**Addendum No. 1  
May 13<sup>th</sup>, 2022**

Project: APSD ATEC Addition & Greenhouse Project  
Aberdeen Public School District  
Aberdeen, South Dakota, 57401

Architect: CO-OP Architecture

10 WINDOW TYPE A - HM STOREFRONT  
3/4" = 1'-0"

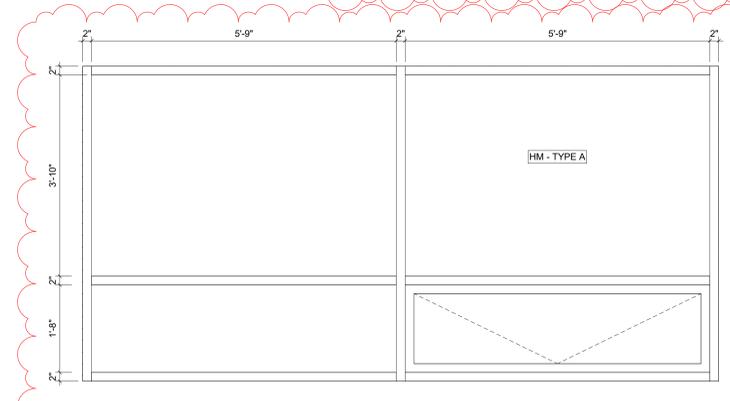
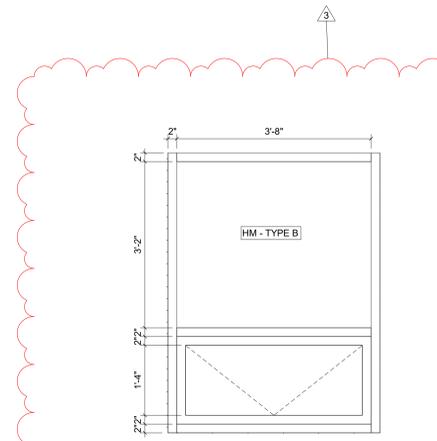
b.) Added Details #11 and #12 for Window Type A and Window Type B w/ Dimensions.

**2.) Construction Civil Site Work Plans; Revisions on Sheet C110:**

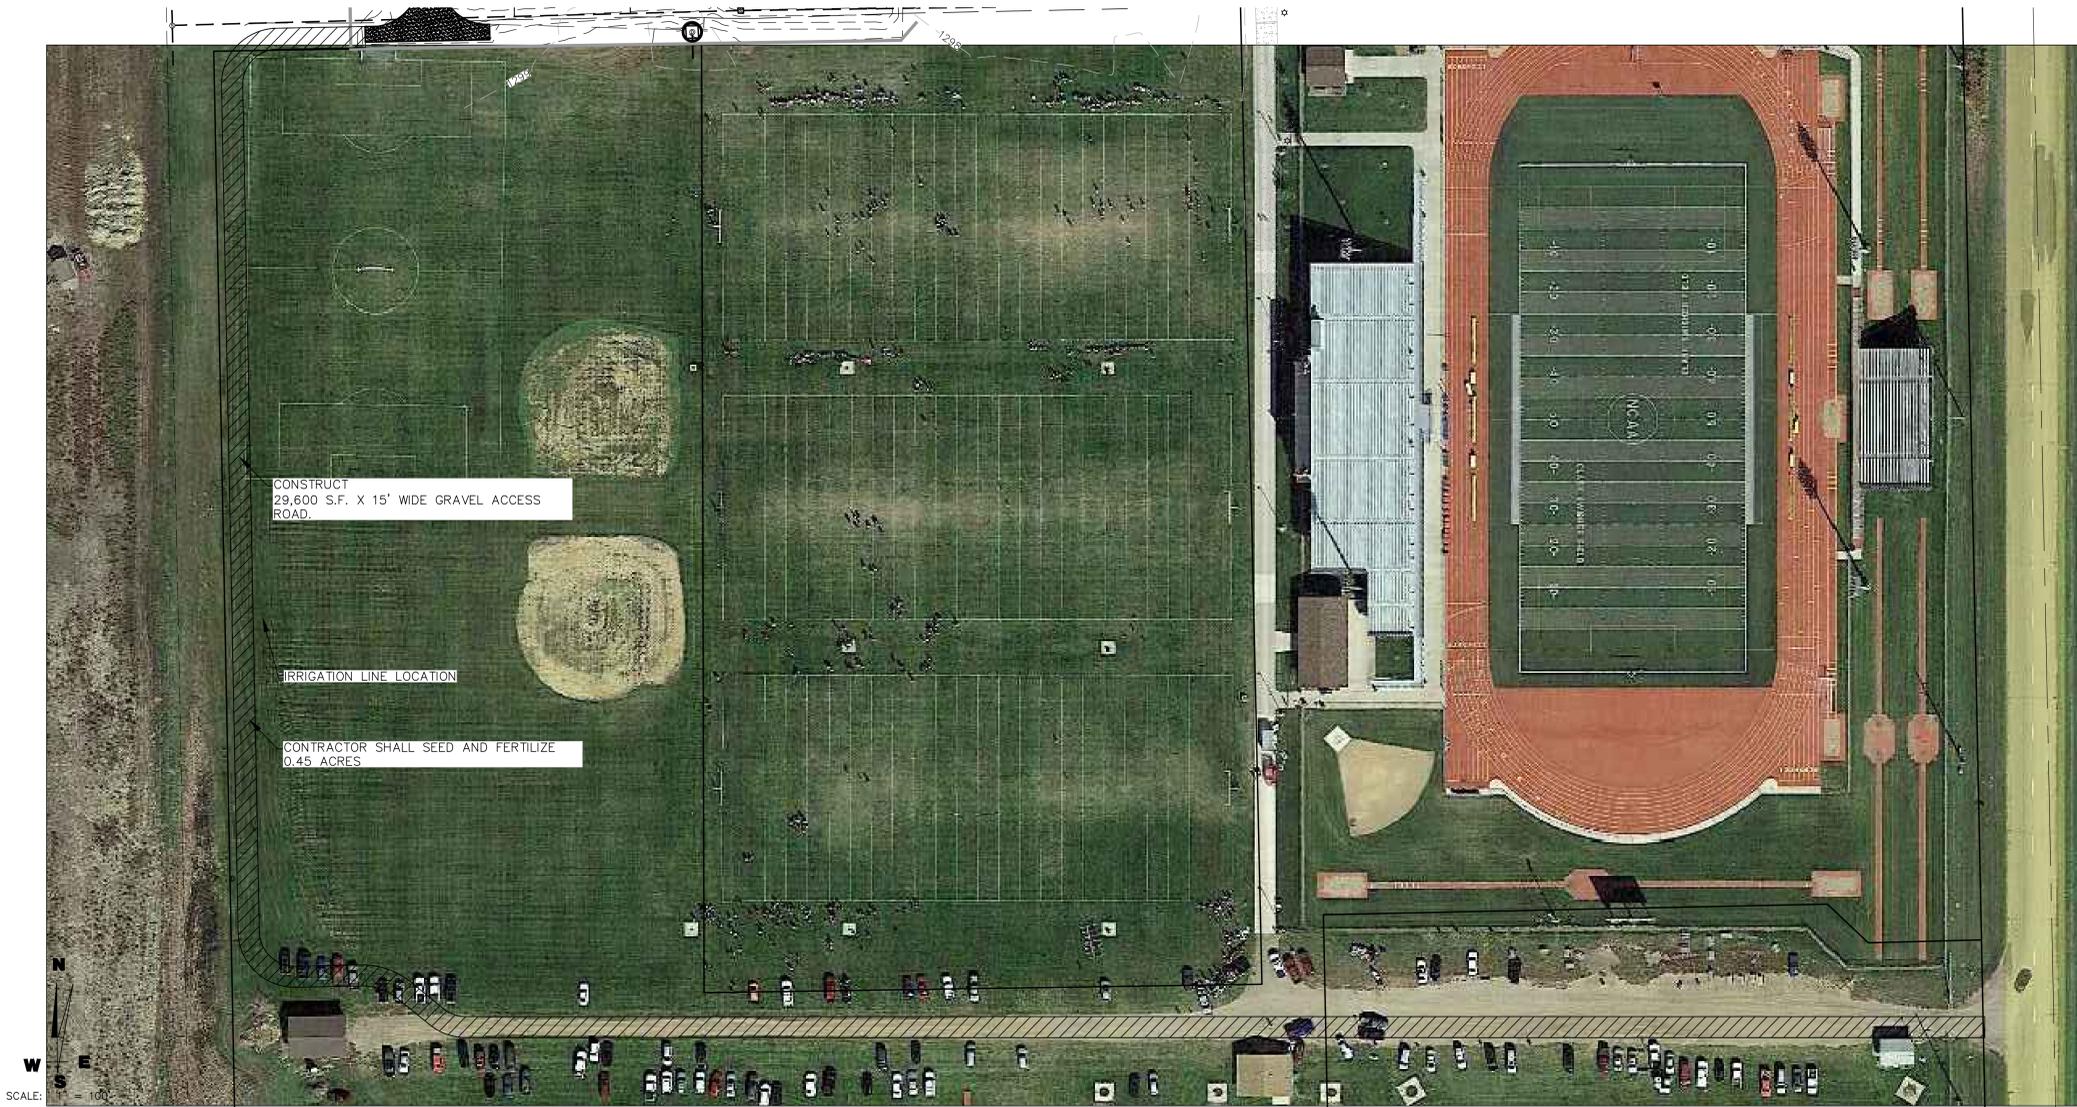
- Enclosed is revised Sheet C110, which includes revised wording of the order of construction of the haul road.
